Location:
41 E. Main Street

Request:
Major Site Plan

Staff Recommendation
Approval subject to
conditions on page 9.

Hudson Planning Commission	SITE PLAN REVIEW – VILLAGE DENTAL
Case No. 25-1022	October 13, 2025

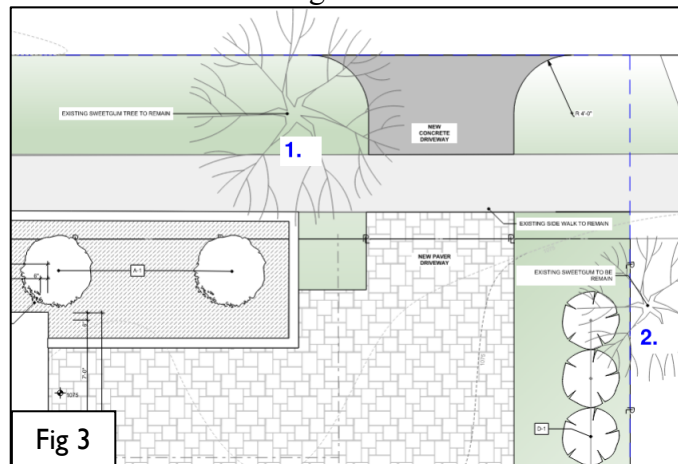
1. If the proposed improvements are made to the site, the existing mature red oak located within the city right of way (identified as a Sweetgum Tree on the plans) would be compromised (Location marked as #1 in Figure 3 below). The tree measures 33" DBH and 36" diameter-at-base and is estimated to be 65 feet tall. The structural root zone (SRZ) is calculated to be 9' radius. No buttress roots within this SRZ shall be severed as it put the tree at risk of failure. Additionally, the tree protection zone (TPZ) would be, at minimum, 49-foot radius. Any cuts, fills, compaction, or otherwise damage to roots within this TPZ could compromise the tree's health and cause decline.

2. Additionally, there is a Sweetgum located on the adjacent parcel that could be affected by the proposed development (Location marked as #2 in Figure 3 below). The proposed area of disturbance falls within the TPZ but not the SRZ. Any damage to roots within the TPZ would potentially lead to a decline in health for the sweetgum.

Staff notes the proposed concrete drive apron is proposed directly adjacent to the mature street tree. Staff has previously recommended the applicant explore the feasibility of entering into a shared access agreement to utilize the neighboring drive to the east. Such would reduce the total number of adjacent curb cuts and potentially protect the mature street tree. Question if the applicant has explored this possibility. Additionally, the applicant should provide additional documentation/protection measures for the adjacent Sweetgum tree.

3. Provide additional documentation regarding protection measures for the existing Sweetgum tree identified in Figure 3 of this report.
4. Revise the landscaping drawings to incorporate evergreens along the eastern property line.

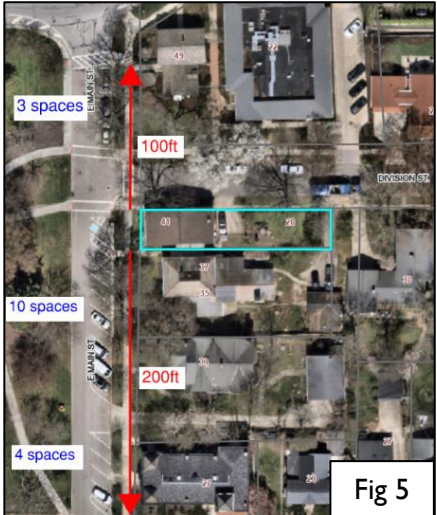
Staff notes existing landscaping would be removed along the eastern property line depicted in Figure 4 below. This landscaping would be replaced by 6 Korean Spice Viburnums. Staff recommends evergreens be planted in lieu or in addition to the viburnums to help buffer the adjacent residential homes to the east.
